Engineering Bulletin: 081110

## Subject: Pull handle for exit devices location change

Panic Exit Device Locations

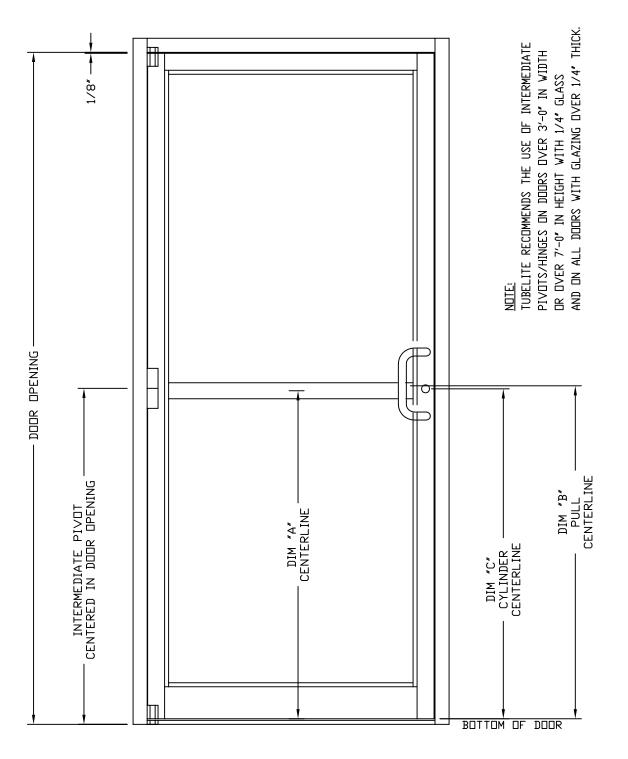
Description: Tubelite will move the location of the pull handle centerline on Panic exit devices on Rim and CVR option. Any order received on September 12th, 2011 and there after will have the new handle location. This will allow the cylinder to be more centered with the pull handle and easier access to lock and unlock. Please see next page for the new pull centerline location.
